CITY OF MILWAUKEE
DEPARTMENT OF PUBLIC WORKS
MILWAUKEE WATER WORKS

OFFICIAL NOTICE NO. 24-1-2015

ADDENDUM NO. 4

**LS-34 COATING AND APPURTENANCES
MODIFICATIONS**

DRAIN PIPE / OVERFLOW DETAIL - DEMO

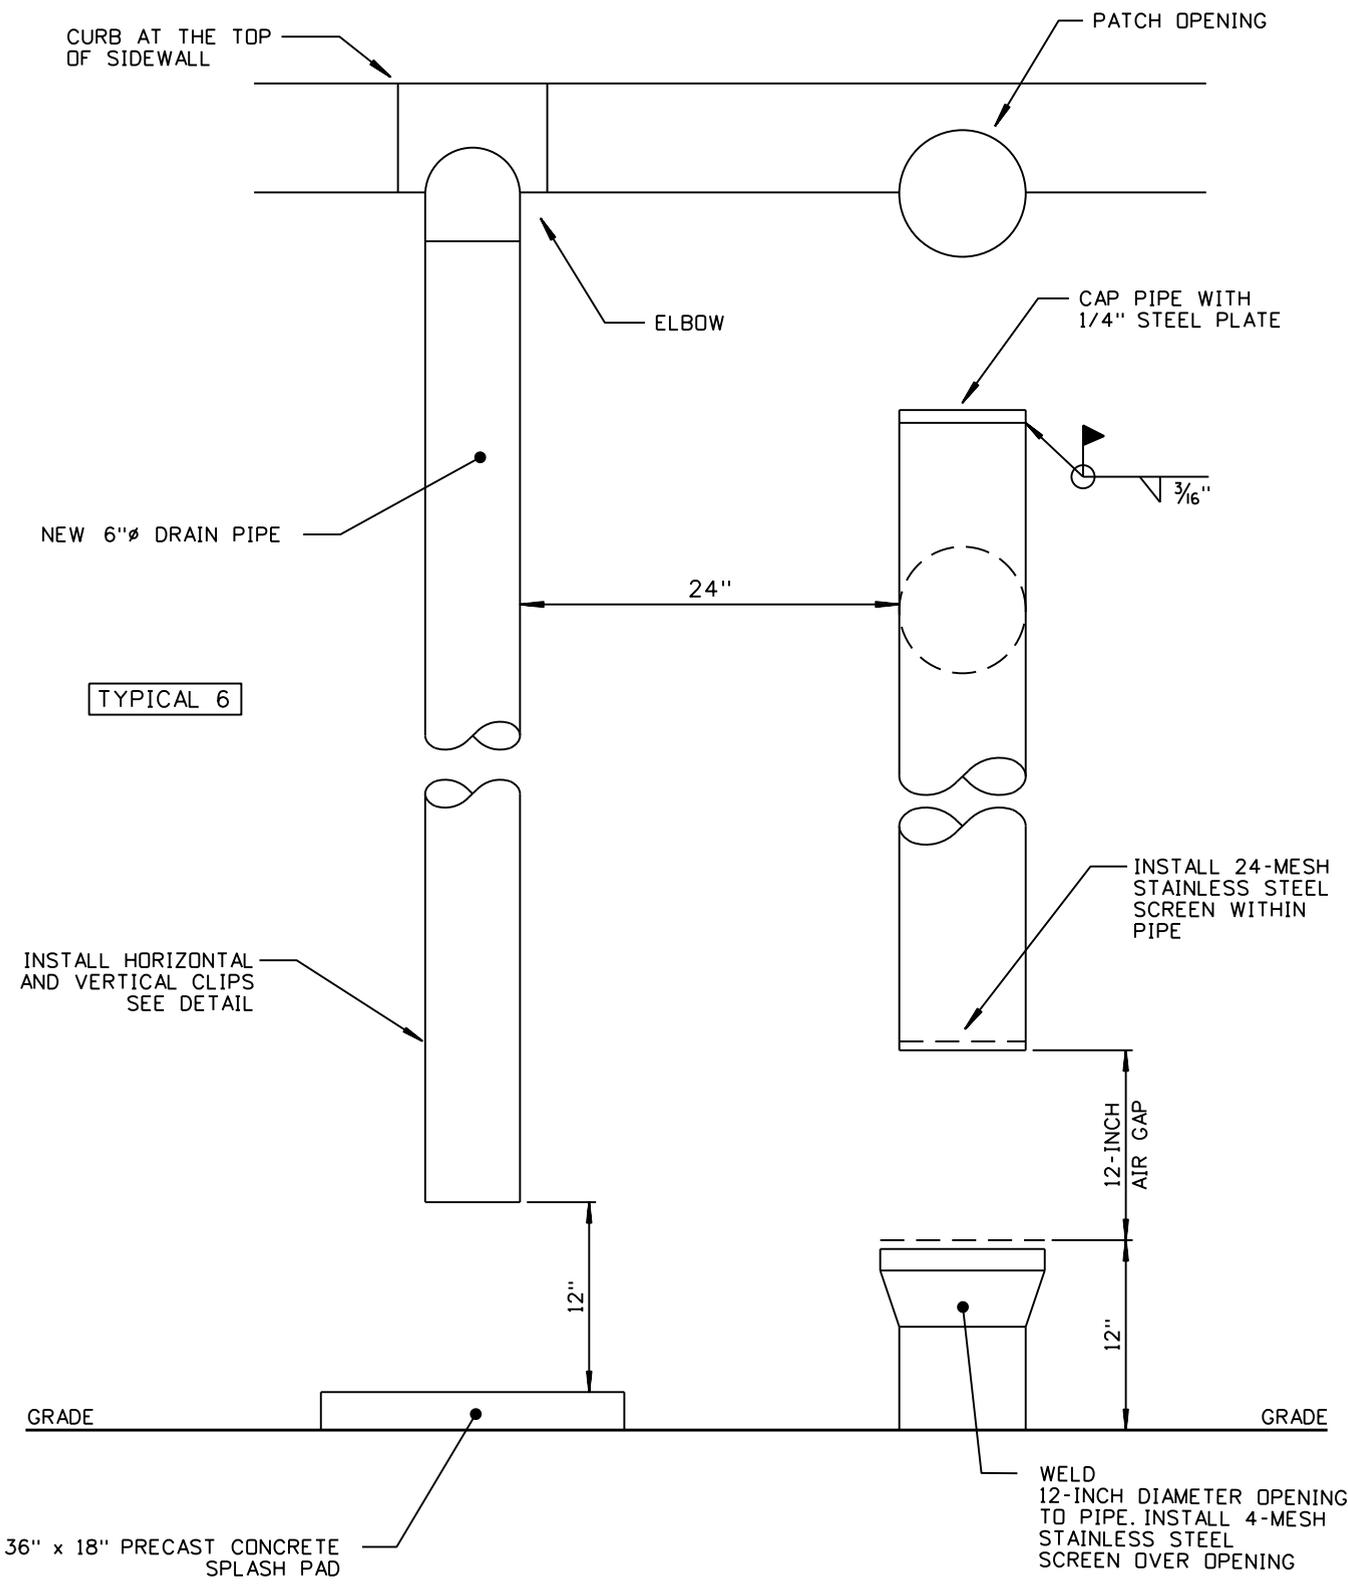
REMOVE SECTION OF CURB
FOR PIPE WELDING AND
REWELD WITH BUTT
WELD JOINT

REMOVE DRAIN PIPE AND PATCH
OPENING. SEE BACK VIEW DETAIL

REMOVE OVERFLOW PIPE
WITH FLARE AND SCREEN

REMOVE SECTION OF
OVERFLOW/ROOF DRAIN
PIPING

- ADD Roof Drain & Tank Overflow Piping
- A. Furnish and install separate piping for Roof Drain and Tank Overflow. Typical 6.
 - B. Remove all slag and spatter.
 - C. Surface prepare and coat in accordance with Sections 09 97 13 and 09 97 13.10.
 - D. See Addendum No 4 24-2015 at <http://mpw.milwaukee.gov/bids/docs/24-2015/> for Drawings.
 - E. Cost is incidental to exterior painting.

Milwaukee **Water Works** Water Engineering
 Department of Public Works
WEST WATER STORAGE TANK - GROUND
 LS-34 COATING AND APPURTENANCES
 MODIFICATIONS
 DRAIN PIPE / OVERFLOW DETAIL

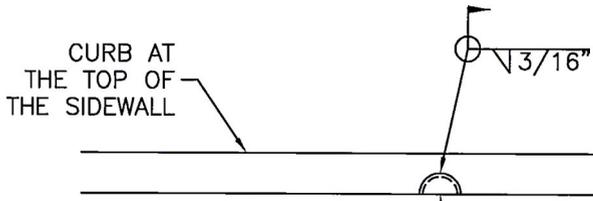
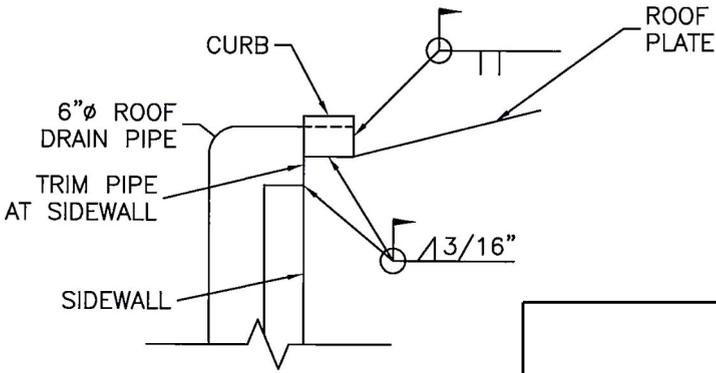
CUT A 1/2 CIRCLE OPENING TO ACCEPT THE NEW 6"Ø SCH. 40 PIPE, TACK WELD EXPANDED METAL SCREEN OVER THE OPENING (McNICHOLS 1/2 #18 FLATTENED, OR APPROVED EQUAL)

REMOVE SCREEN GRIND FLUSH AND INSTALL A 1/4" PATCH PLATE, OVERLAP OPENING 1/2" MIN. AROUND HALF CIRCLE AND MAKE FLUSH WITH THE ROOF PLATE ON THE BOTTOM, FRONT SIDE REPAIR TO BE SIMILAR, ONLY A FULL CIRCLE PATCH WILL BE REQ'D

LS-34 COATING AND APPURTENANCES MODIFICATIONS DRAIN PIPE SUPPORTS

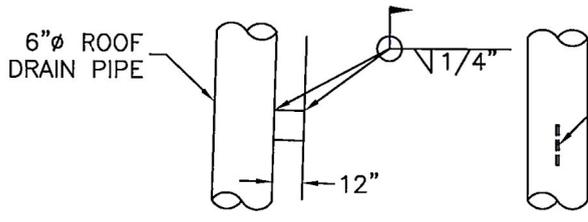
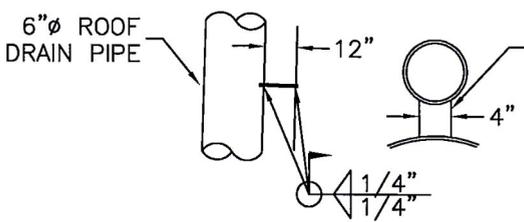
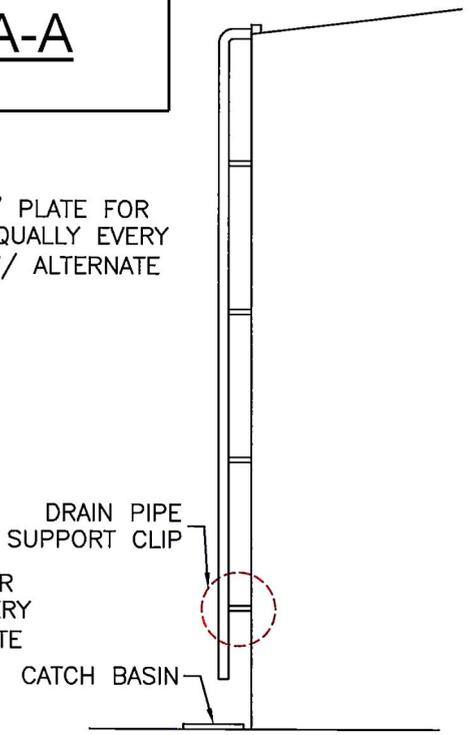
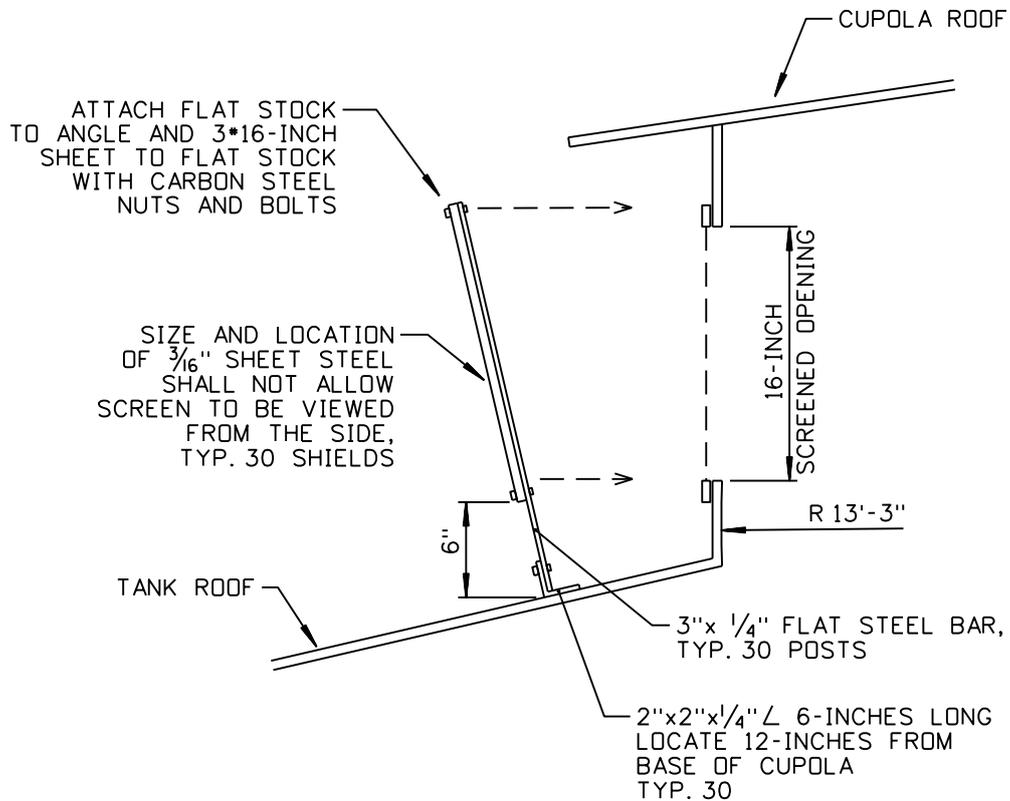
12" x 4" x 3/8" PLATE FOR CLIPS SPACED EQUALLY EVERY 6' ON CENTER W/ ALTERNATE HORIZONTAL CLIP

12" x 4" X 3/8" PLATE FOR CLIPS SPACED EQUALLY EVERY 6' ON CENTER W/ ALTERNATE VERTICAL CLIP

**LS-34 COATING AND APPURTENANCES
MODIFICATIONS
VENT SHIELD**

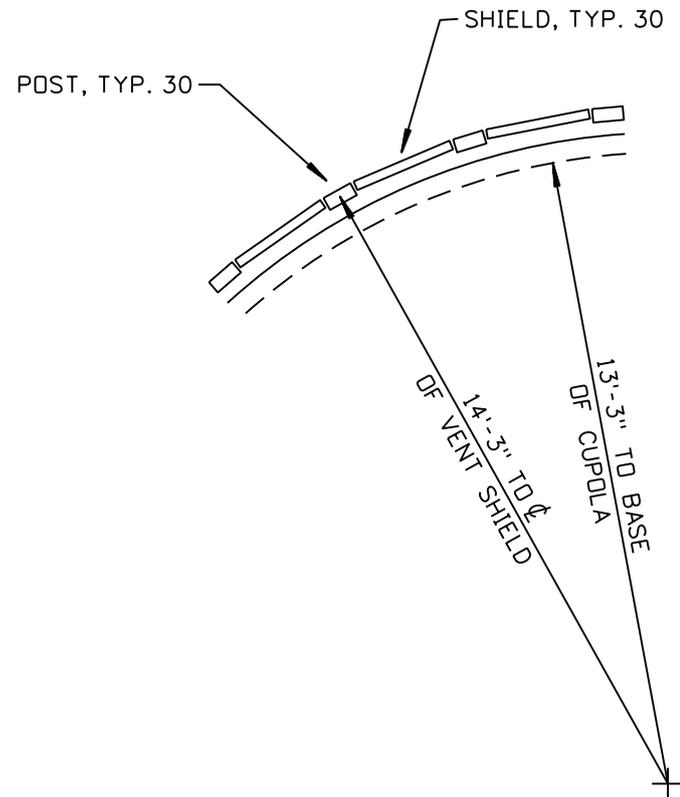
- ADD Vent Shield
- A. Furnish and install Vent Shield around perimeter of cupola.
 - B. Remove all slag and spatter.
 - C. Surface prepare and coat in accordance with Sections 09 97 13 and 09 97 13.10.
 - D. See Addendum No 4 24-2015 at <http://mpw.milwaukee.gov/bids/docs/24-2015/> for Drawings.
 - E. Cost is incidental to exterior painting.

**LS-34 COATING AND APPURTENANCES
MODIFICATIONS
PLAN OF CUPOLA SCREEN**

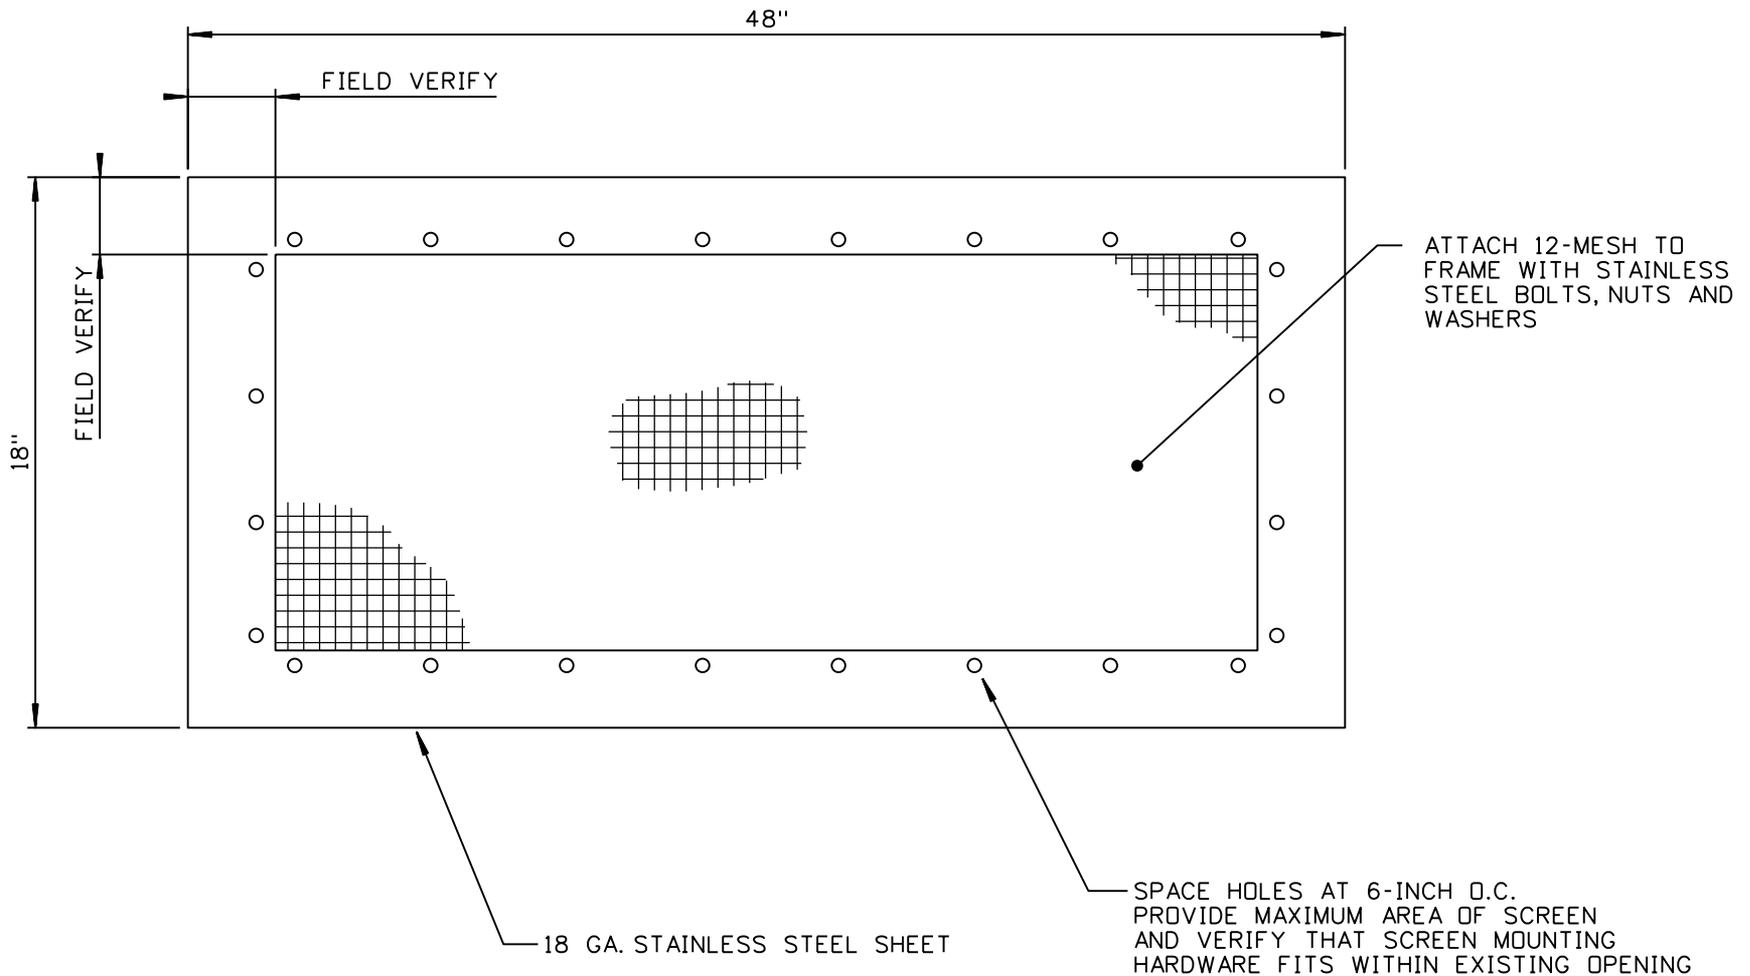
- DELETE Cupola Roof Vent Repair
Delete Items A., B., C., and D.
- ADD Cupola Roof Vent Repair
- A. Furnish and install Cupola Screens around perimeter of cupola.
 - B. Remove all slag and spatter.
 - C. Surface prepare and coat in accordance with Sections 09 97 13 and 09 97 13.10.
 - D. Provide Concrete Splash Block
 - E. See Addendum No 4 24-2015 at <http://mpw.milwaukee.gov/bids/docs/24-2015/> for Drawings.
 - F. Cost is incidental to exterior painting.
